DECISIONS OF THE QUEENSTOWN LAKES DISTRICT COUNCIL

CHANGE OF CONDITIONS – SECTION 127

Applicant:	Arrowsouth Properties Limited
RM reference:	RM210061
Application:	Application under section 127 of the Resource Management Act 1991 (RMA) to change conditions 1, 4 and 9(k) of RM161093 (as varied by RM181358) to provide for an amended trail design
Location:	Lot 103, McDonnell Road, Arrowtown
Legal Description:	Lot 102-103 Deposited Plan 535793 Record of Title 911161
Zoning:	ODP: Arrowtown South (and part Low Density Residential) PDP: Lower Density Suburban Residential (relates to leg in only)
Activity Status:	Discretionary
Decision Date	20 August 2021

Consent is sought to change conditions 1, 4 and 9(k) of RM161093 (as varied by RM181358) to provide for an amended trail design.

TRAIL 01 & 02 TYPICAL CROSS SECTION
Scale 1 : 40 (@ A3)

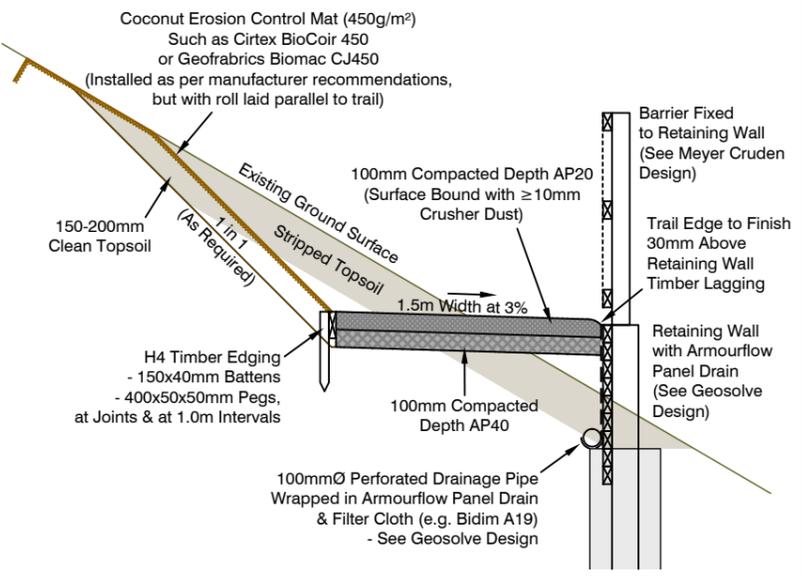
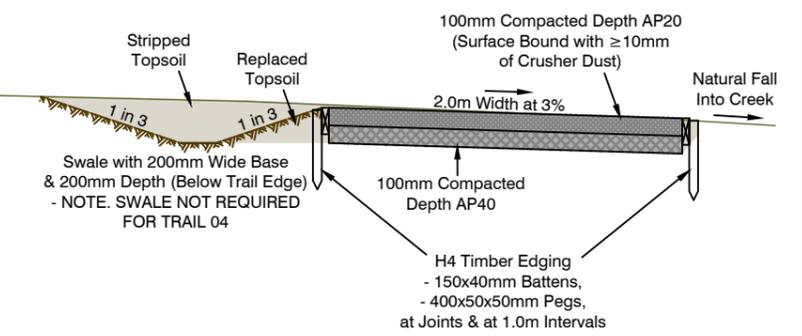
The application states that the revised Trail 1 surface characteristics will consist of a compacted gravel surface with low retaining and timber edging. The proposed steps will be constructed using similar materials to the remainder of the trail, with timber battens along riser edges and compacted gravel between risers. Furthermore, the layout (width, height and depth) of the steps will be in accordance with SNZ HB 8630:2004 and Building Code guidelines. This construction will promote usability and safety, particularly in terms of minimising trip risk and maximising slip resistance. The adjoining timber and wire mesh barrier will also assist usability and safety (being compliant with SNZ HB 8630:2004) and will double as a hand rail (see page 10).

- Arrowfields Trails Design Drawings, Trails Layout & Typical Cross Sections, Plan No. C1346_01, Issue A dated 25/01/21 (Original drawing date Sept 2018)

APPROVED PLAN:
TRAIL 01 - LONGITUDINAL SECTION
 HORIZ. 1:750 VERT. 1:500
Friday, 20 August 2021

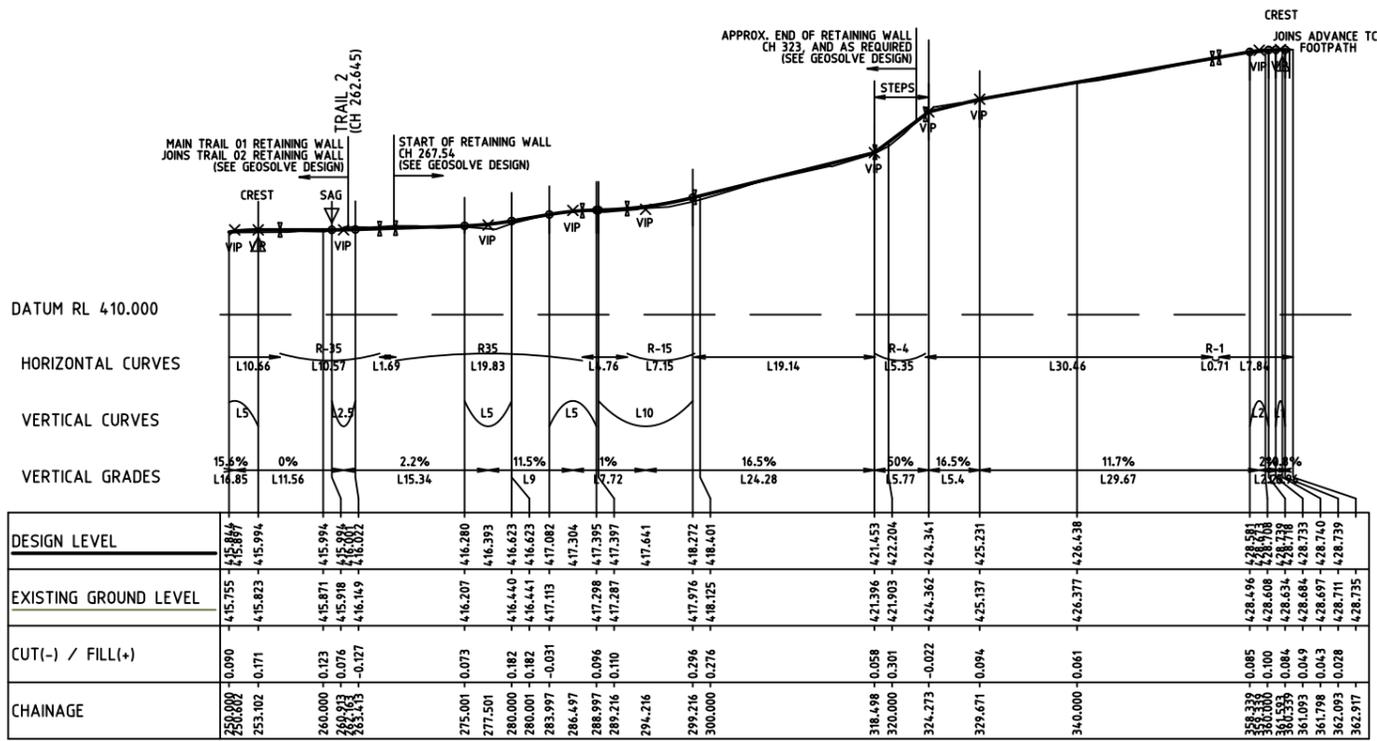
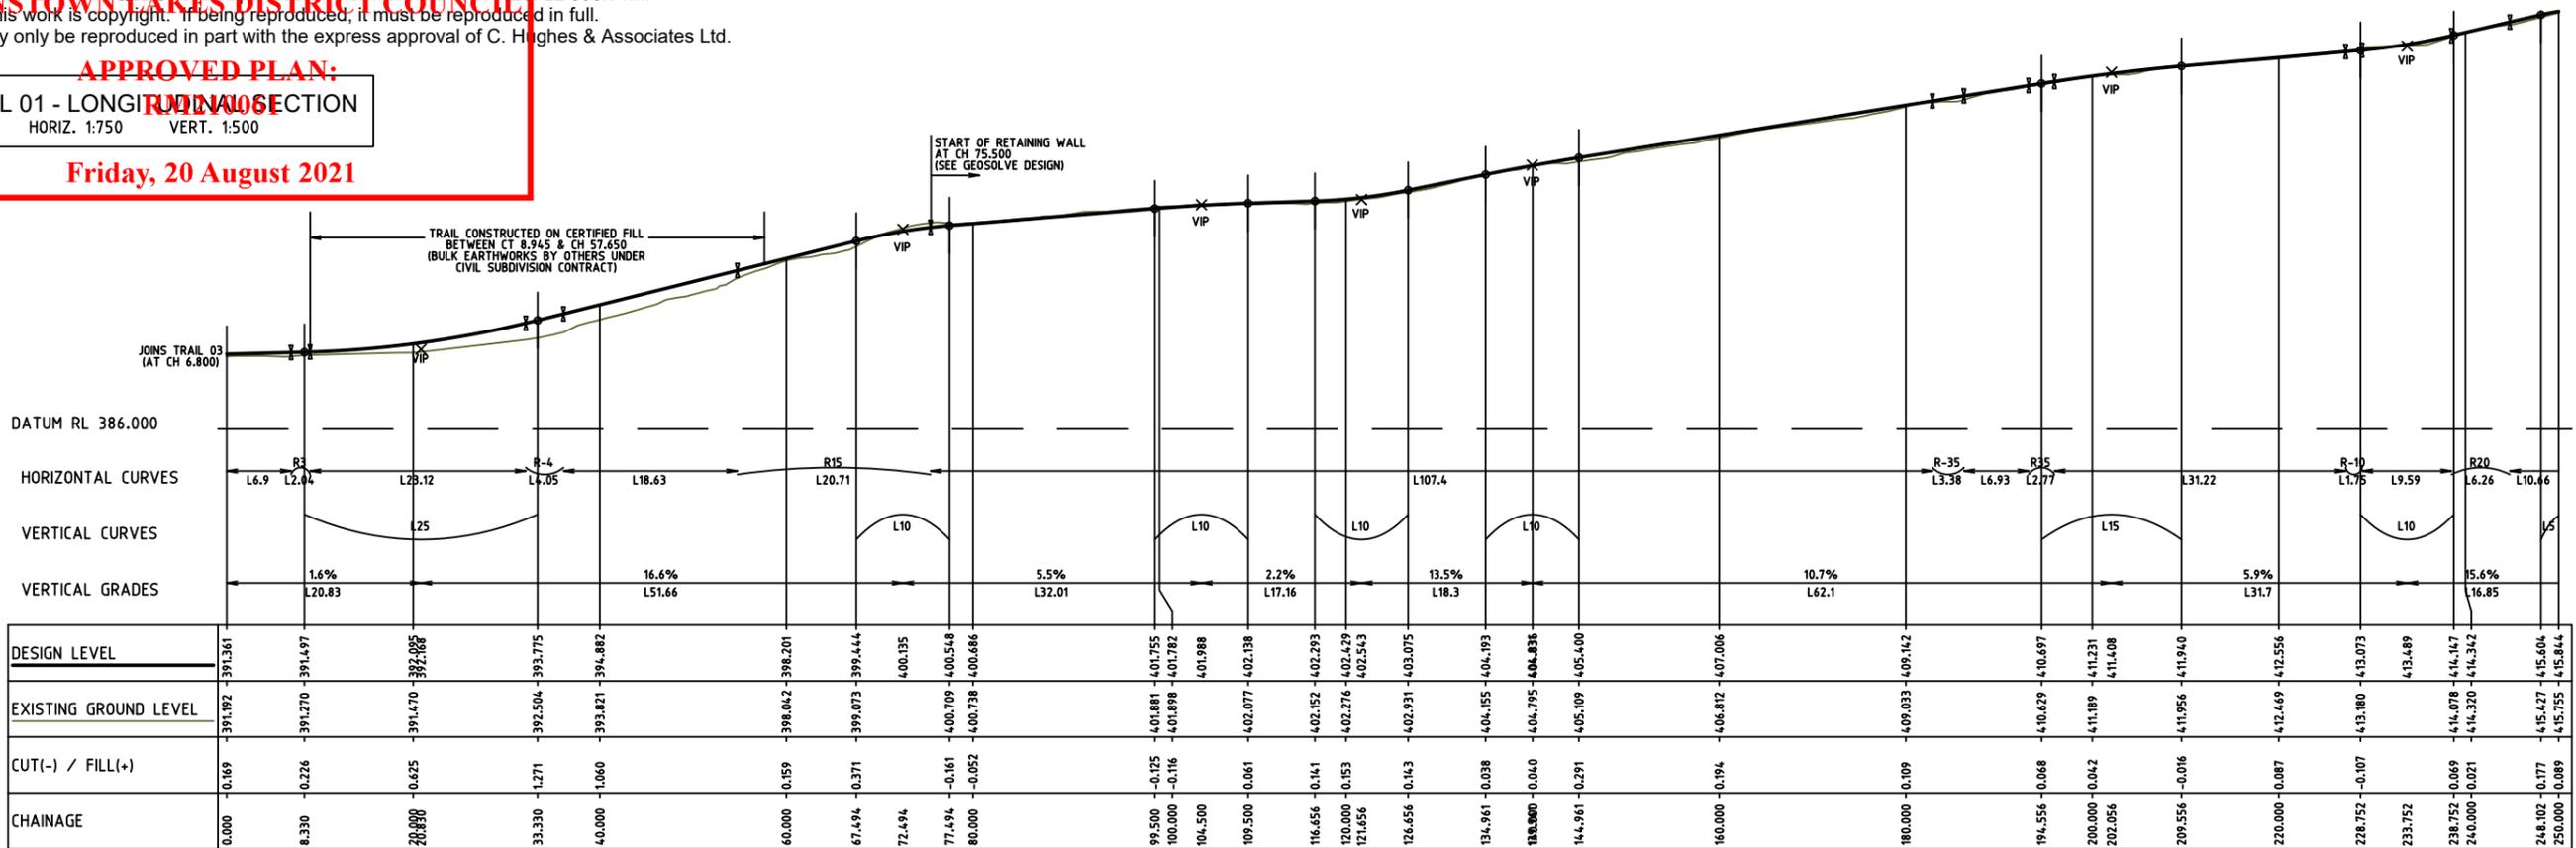
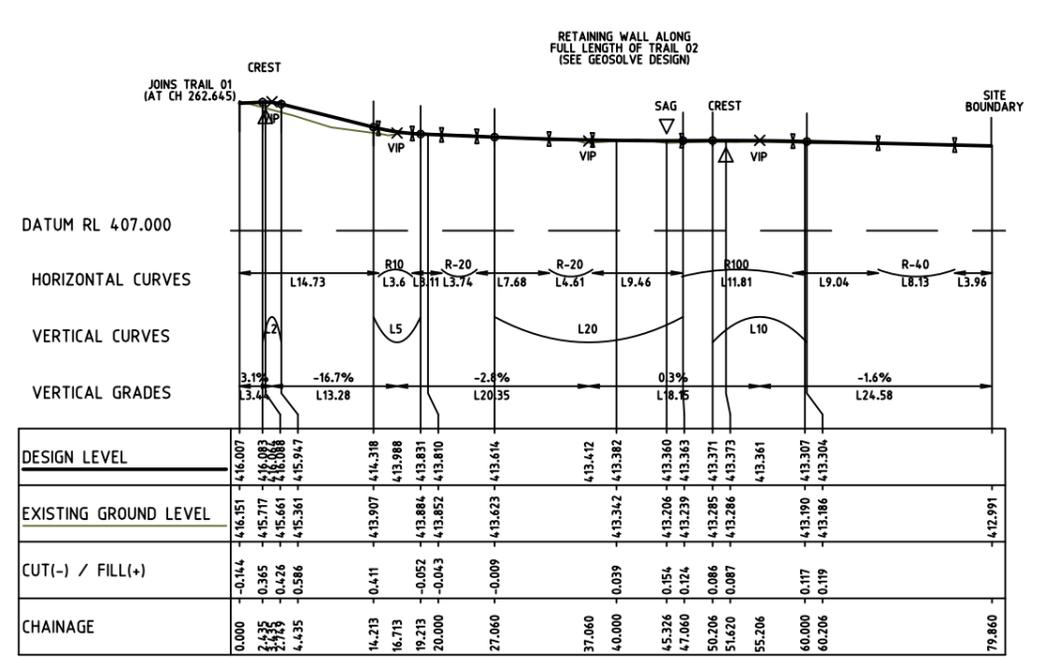
- Arrowfields Trails Design Drawings, Escarpment Trails Longitudinal Sections, Plan No. C1346_02, Issue A dated 25/01/21 (Original drawing date Sept 2018)

**APPROVED PLAN:
RM210061**

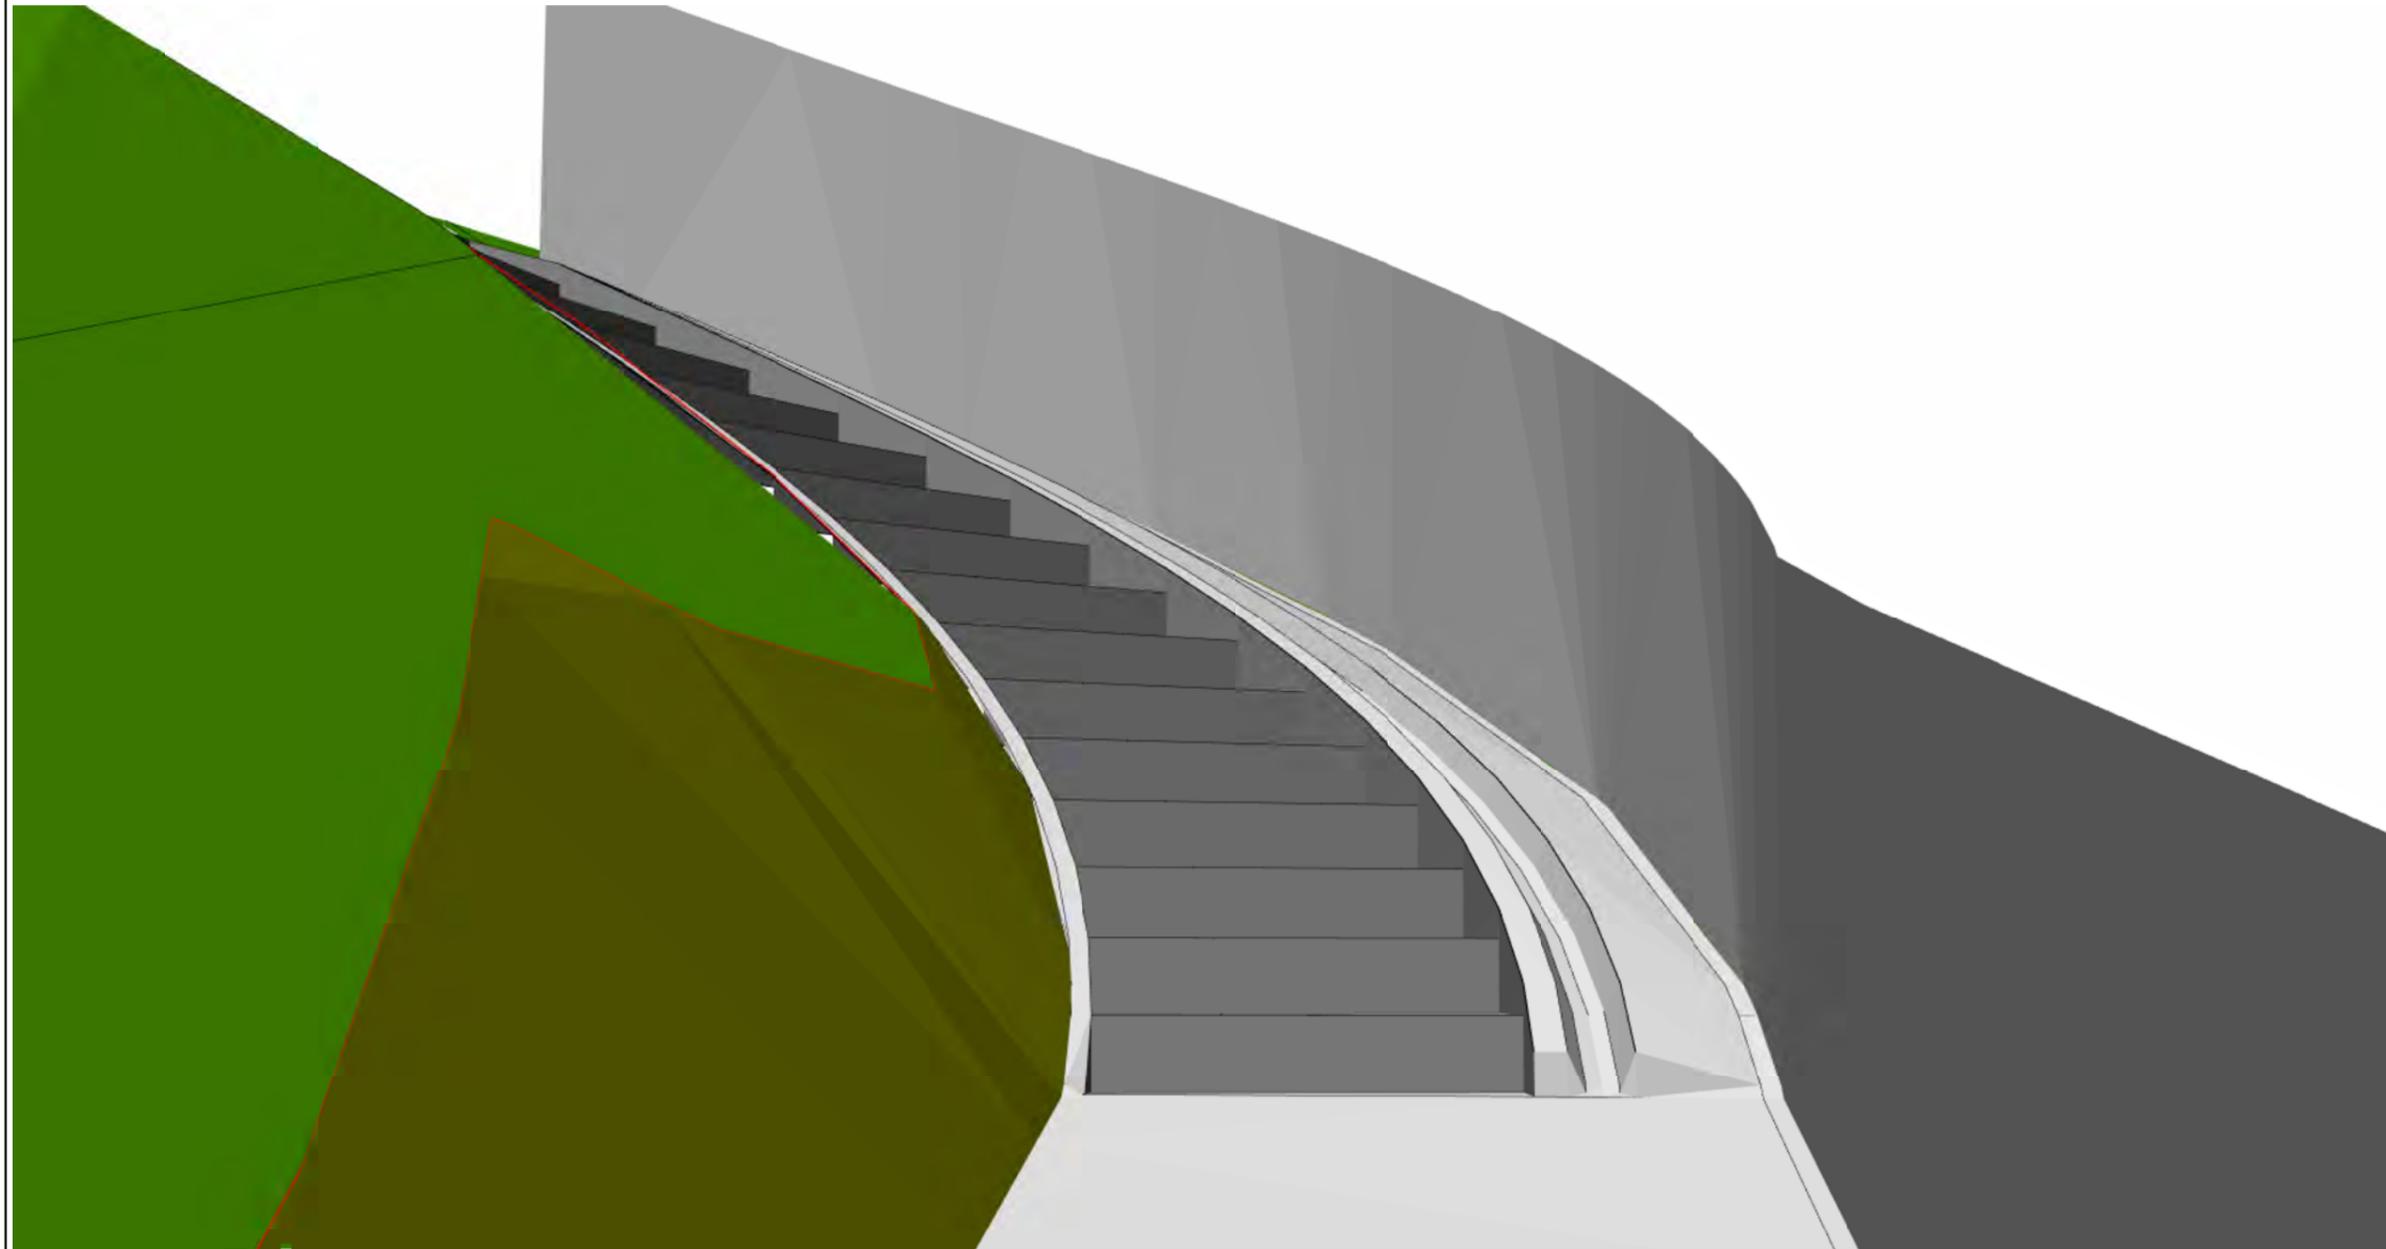
- RM161093 Arrowsouth Properties Alternative Upper Trail 1 Design, Drawing No. C1471, Revision C, Sheets 1-3, Dated 15/04/21 (Original drawing date April 2020)

The proposed trail design is as shown and noted on the attached drawings (Drawing No. C1471, Sheets 1-3), and the existing/consented elevated Boardwalk level is depicted on Sheet 2 (the Longitudinal Section, with tabulated height differences) to aid understanding of the change in level between the consented and proposed surfaces. Sheet 3 of the drawing set is an Indicative Perspective View of the proposed curved steps with bicycle wheeling ramp, with reference to the perspective viewpoint shown on Sheet 1. This Indicative Perspective View is a

4. All trail works shall be carried out in accordance with the Queenstown Lakes District Council's policies and standards, being QLDC's Cycle Trail Design Standards and Specifications dated 27 August 2015 and subsequent amendments to that document up to the date of issue of any resource consent, with the exception of the "steps with bicycle wheeling ramp" portion that shall be constructed in accordance with drawing C1471 Revision C and as unless otherwise agreed by the Parks and Reserves Manager.
